**DOCUMENT 00 91 02
ADDENDUM NO. 2**

PROJECT: 2024 Smith and Spillane MS Renovations
BID DATE: **Thursday, February 20, 2025 (no Change)**
FROM: Carolina Weitzman, A.I.A.
Natex Corporation Architects
447 Heights Blvd, Houston, TX 77007
TO: **Prospective Bidders**

SMITH MS

Project Number: 23073
 Date: 26 JANUARY 2025
 Drawn By: WHL / KLO
ELECTRICAL LIGHTING
FIRST FLOOR PLAN -
AREA 'D'
E2.04

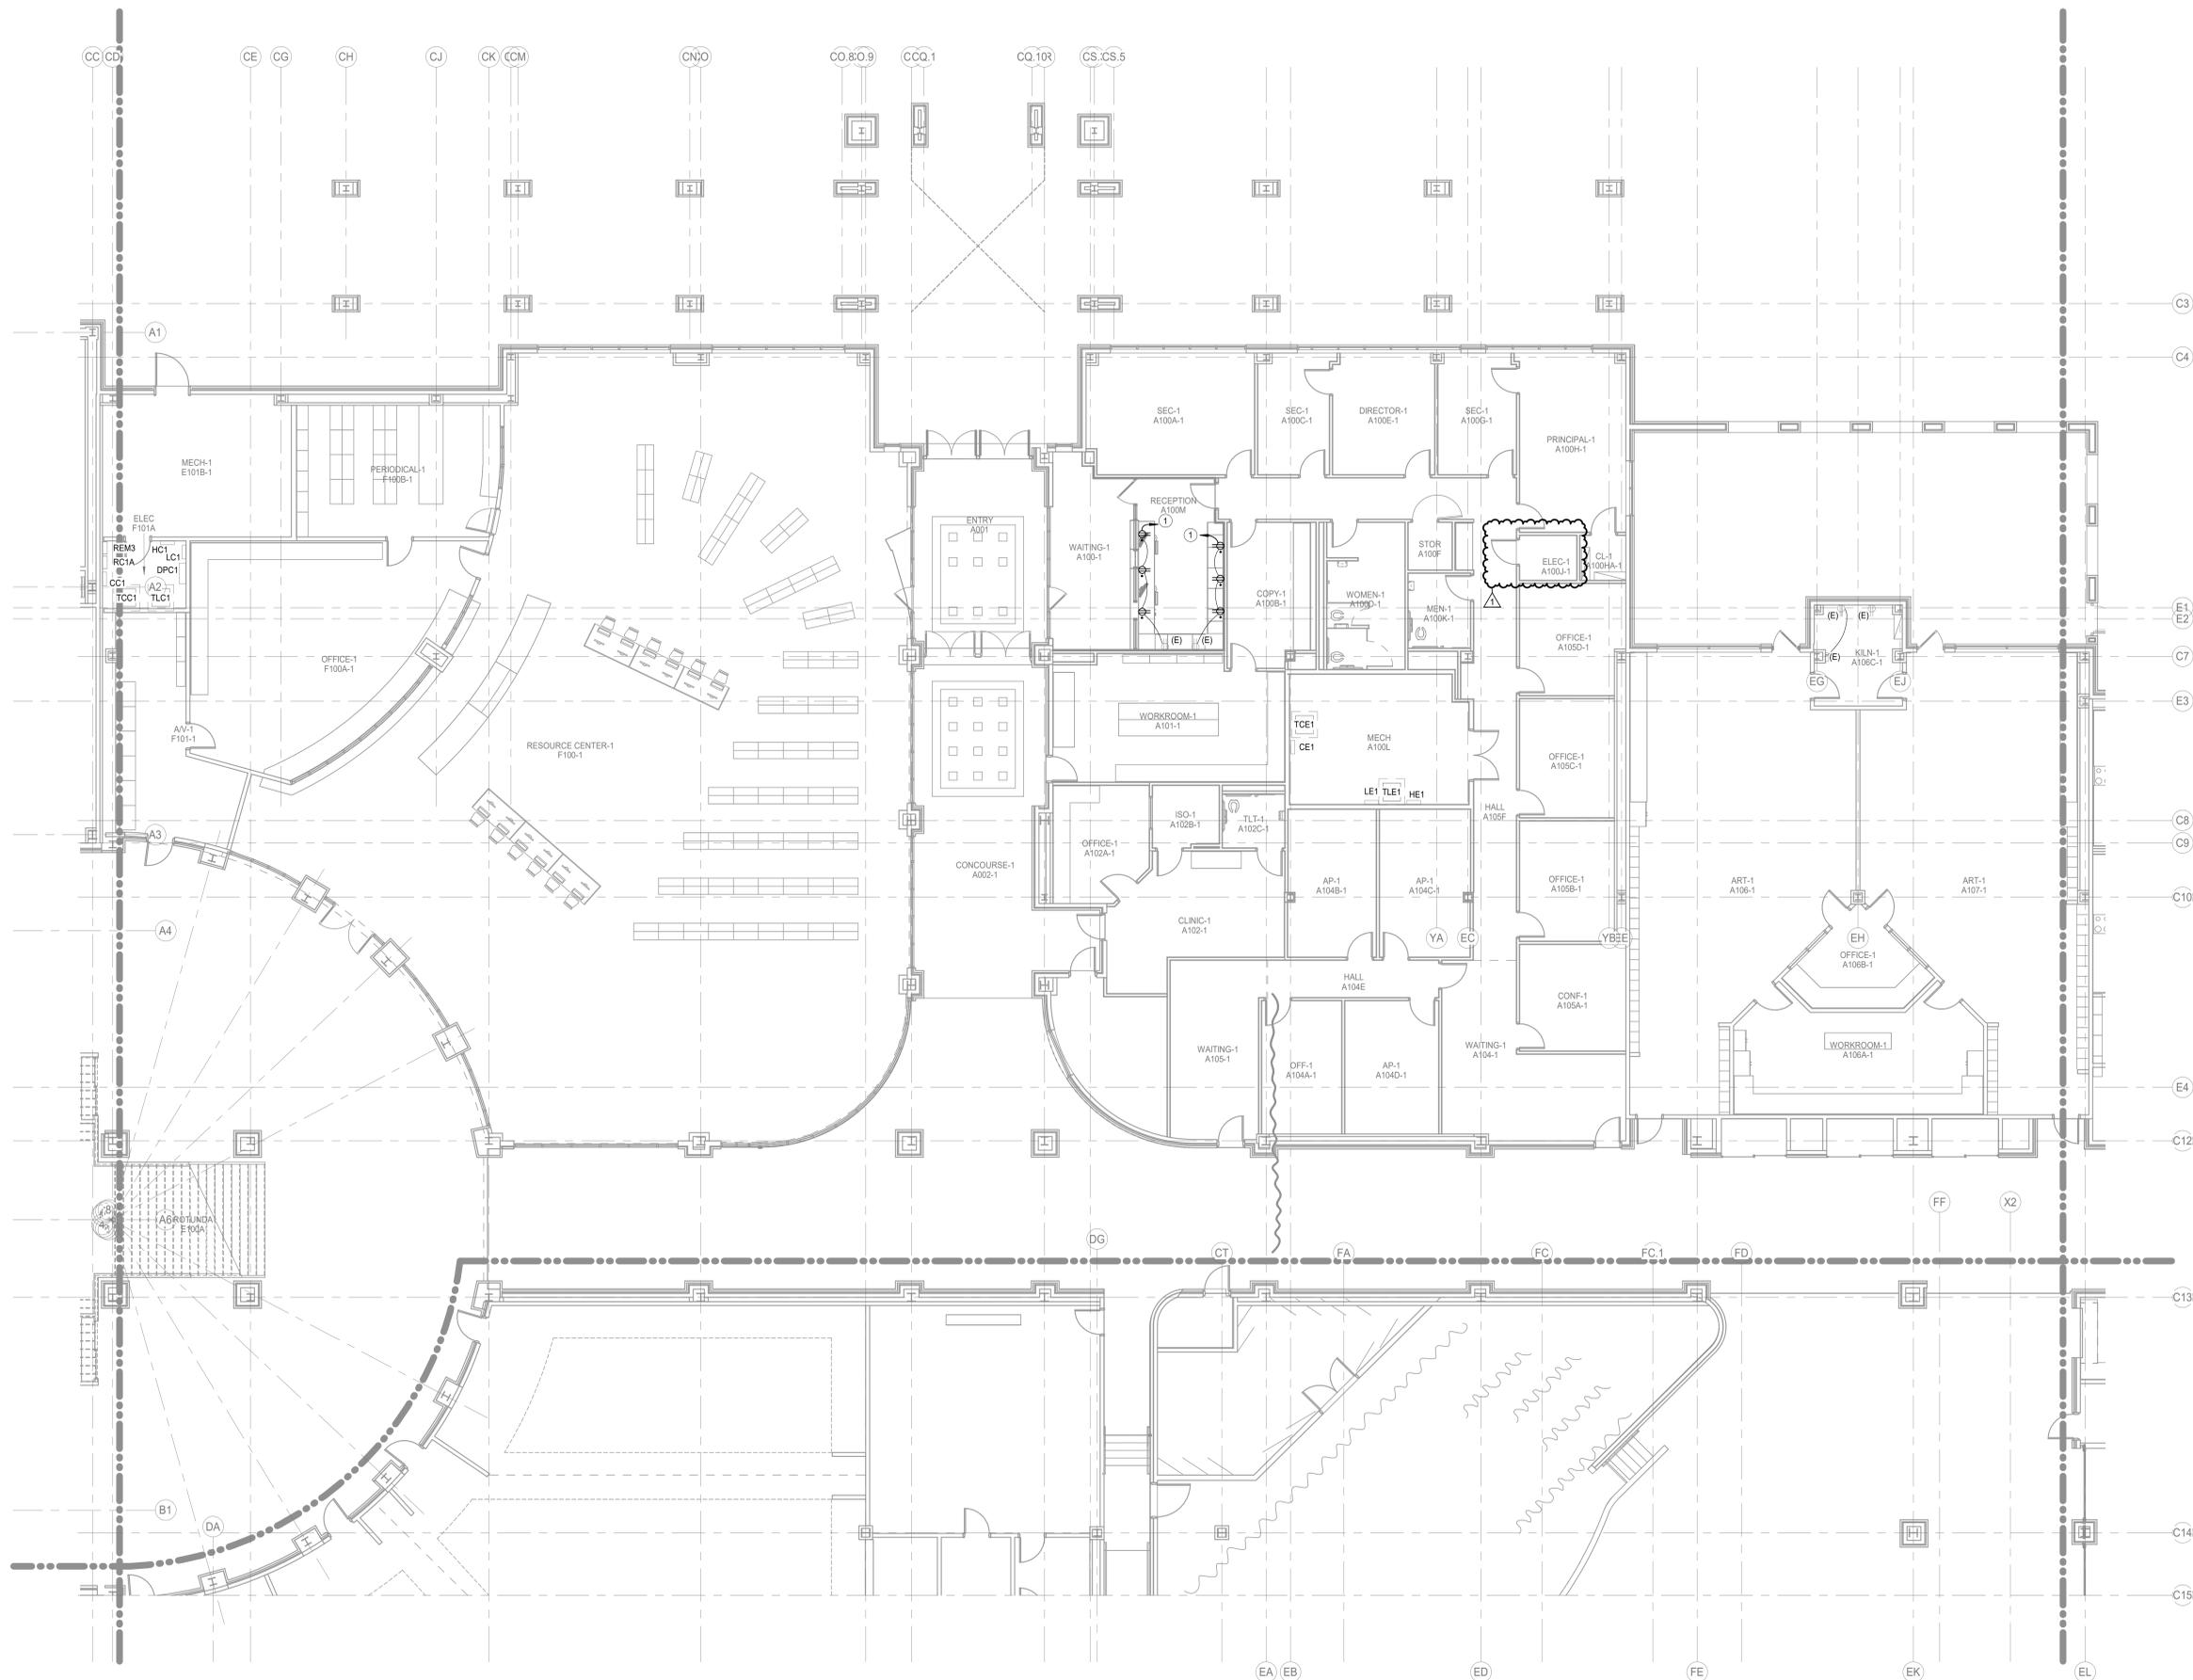
- a. Lighting layout revision in SPEECH-1 D101-1.
14. E3.03 - ELECTRICAL POWER FLOOR PLAN -LEVEL 1 -AREA C
 - a. Removed FACP From ELEC-1 A100J-1.
15. E3.04 – ELECTRICAL POWER FLOOR PLAN – LEVEL 1 – AREA D

Project Number: 23073
 Date: 26 JANUARY 2025
 Drawn By: WHL / KLO
 PLUMBING UNDERFLOOR PLAN - AREA 'D'
P2.04
 of

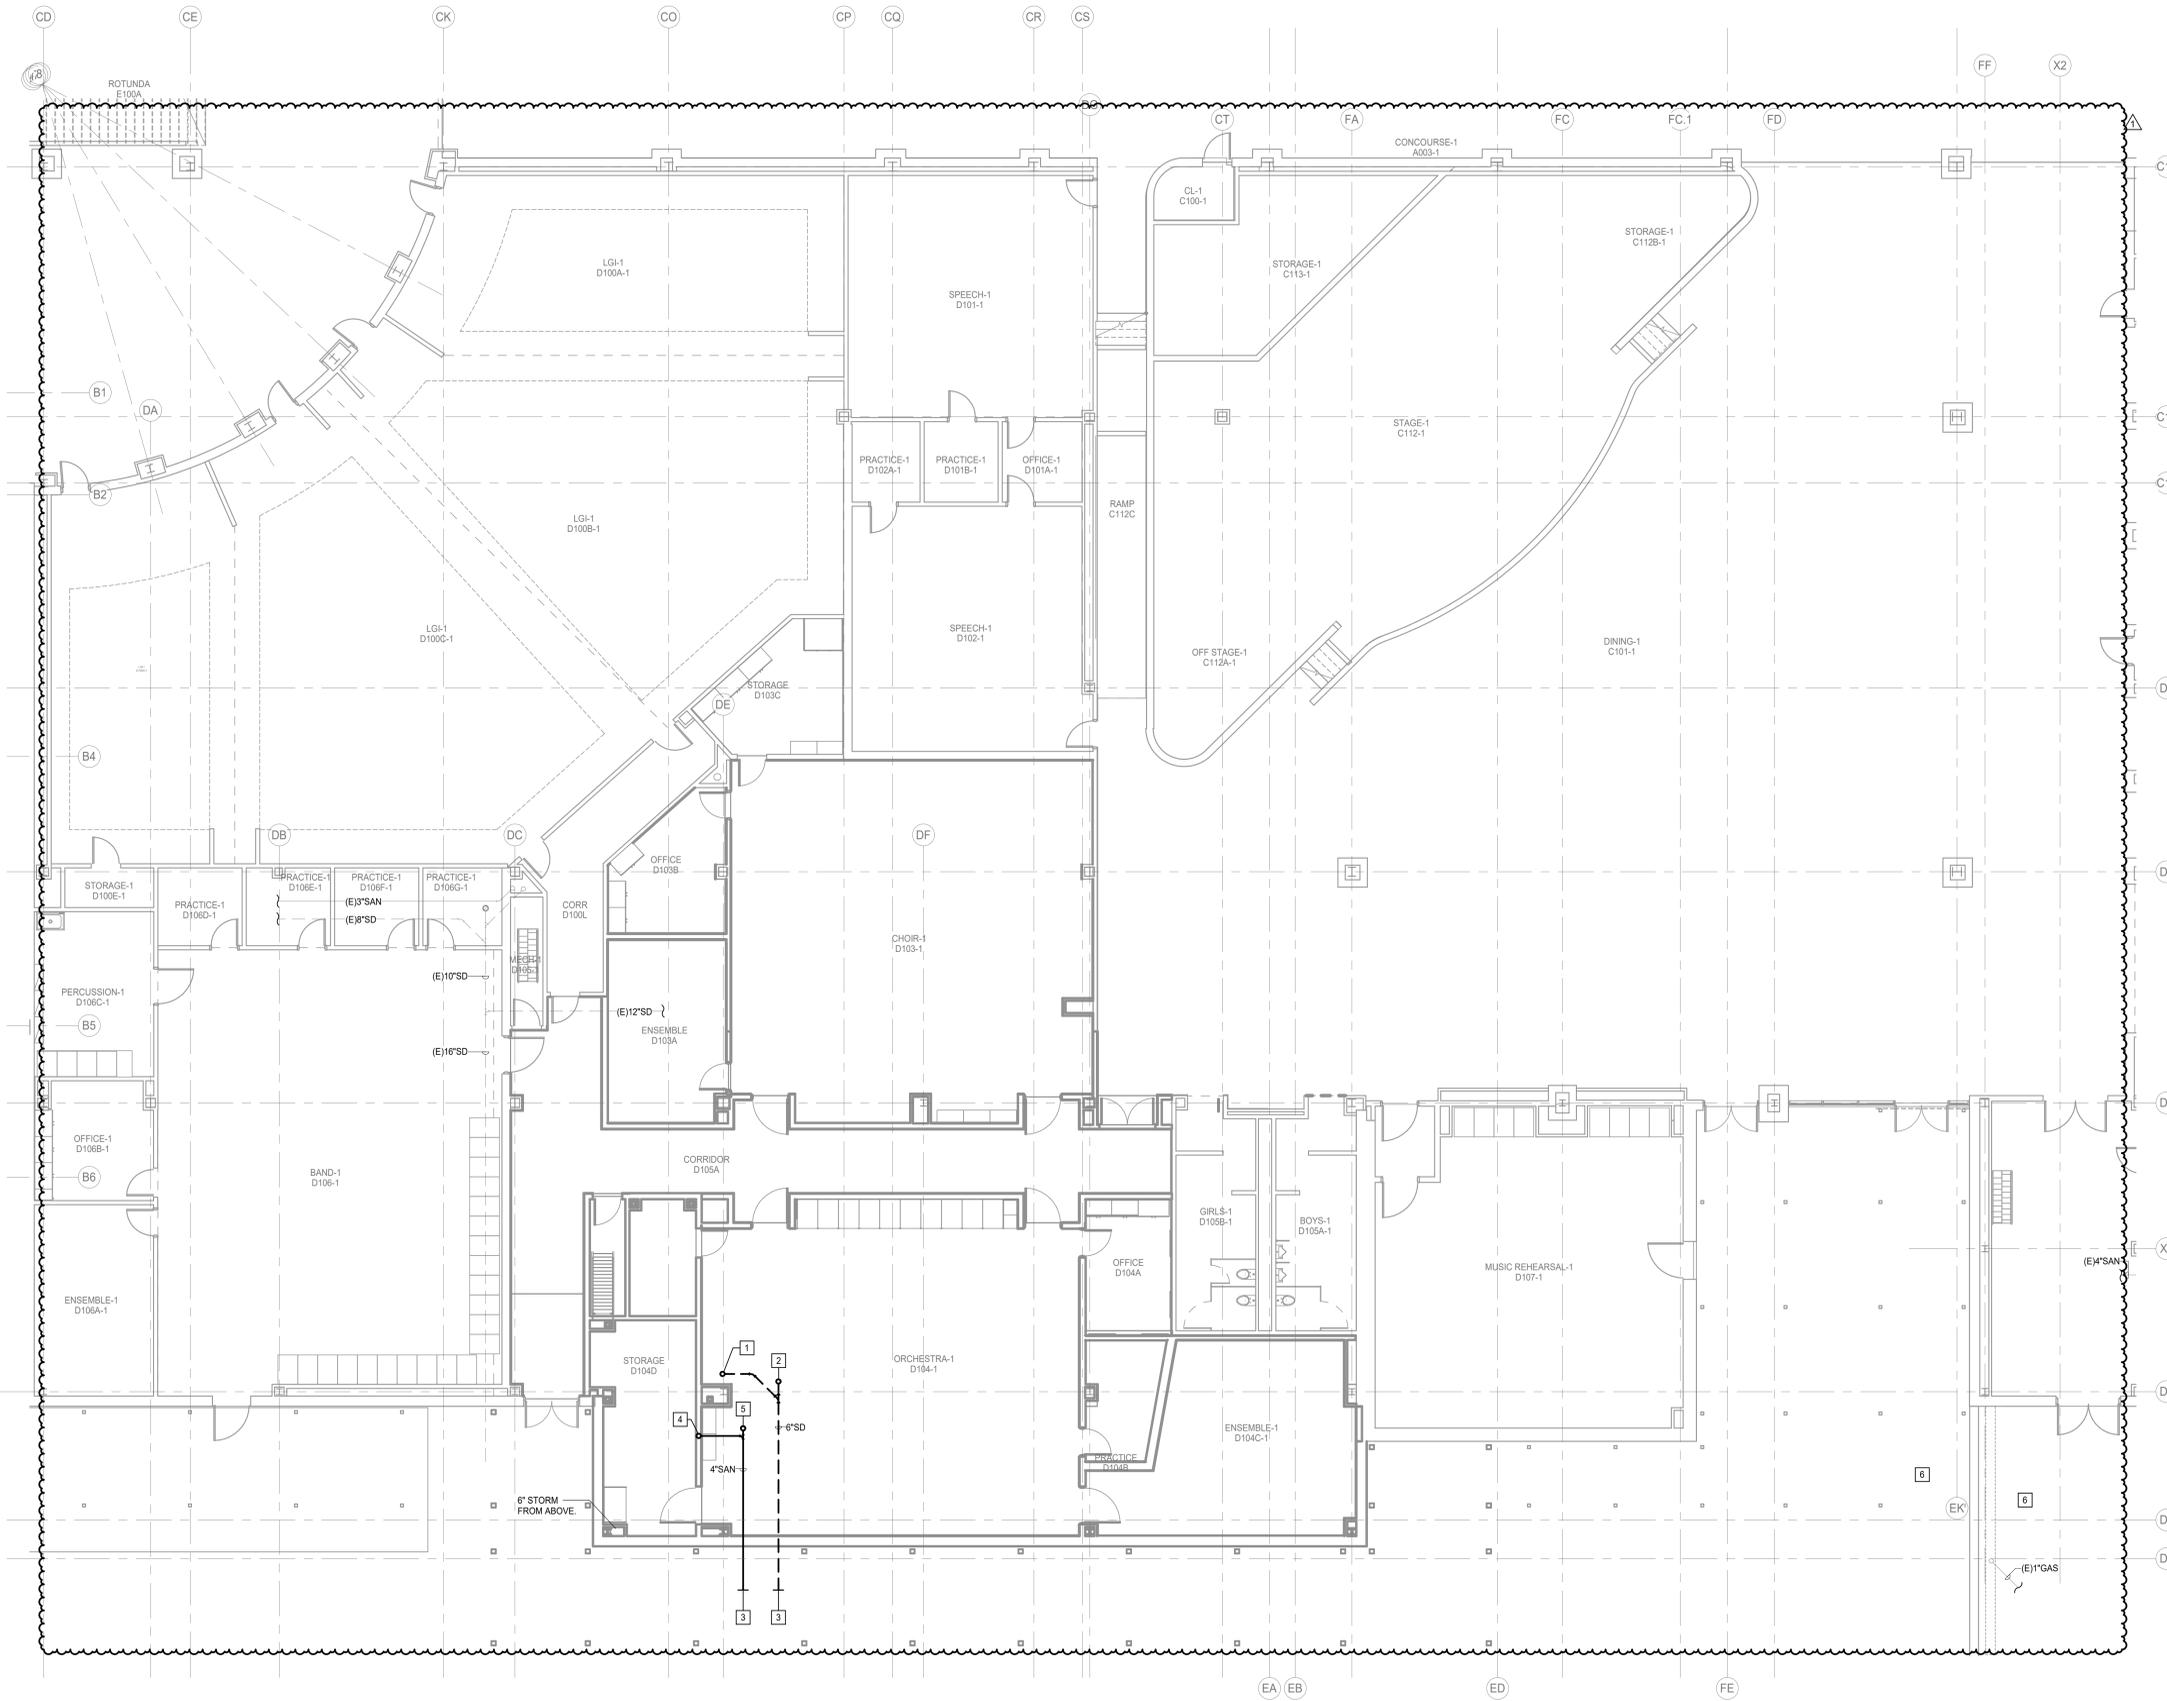
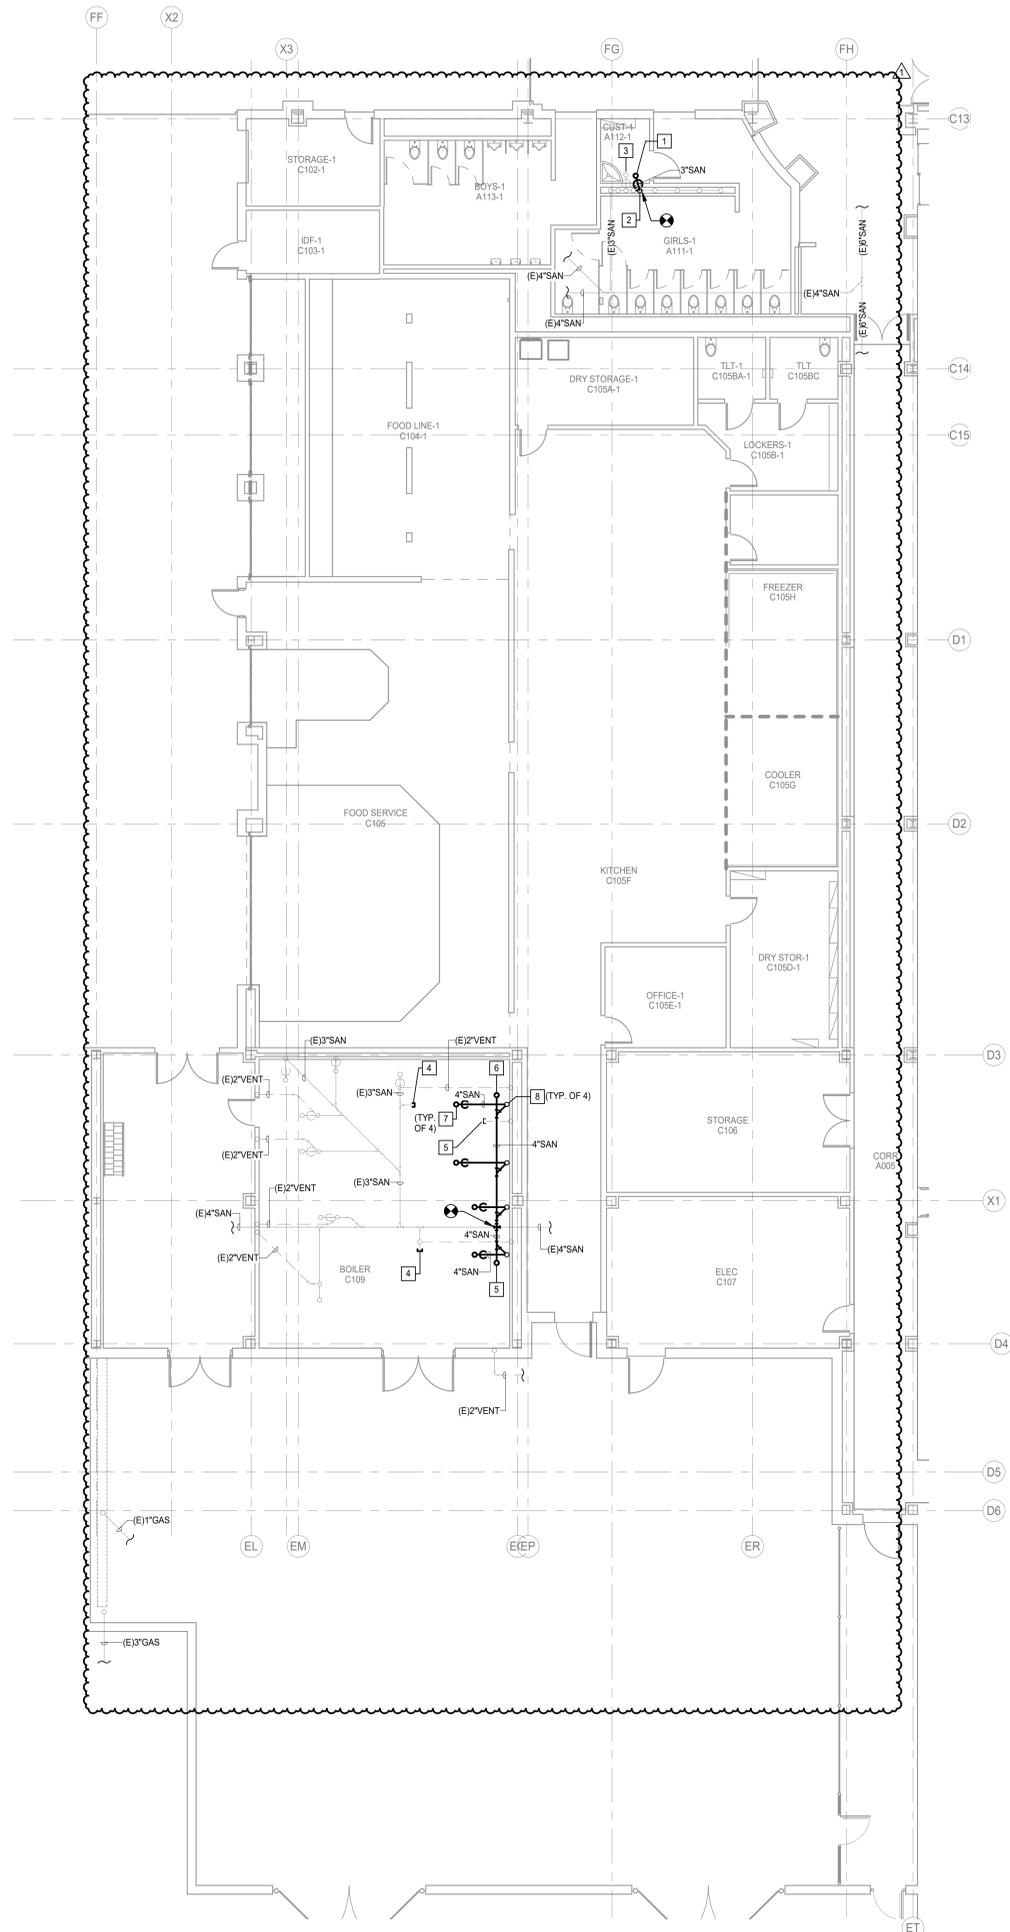
- a. Refer to revised sheet for clarifications to storm lines.
23. P2.04 – PLUMBING UNDERFLOOR PLAN – AREA ‘D’
 - a. Refer to revised sheet for clarifications to storm lines.
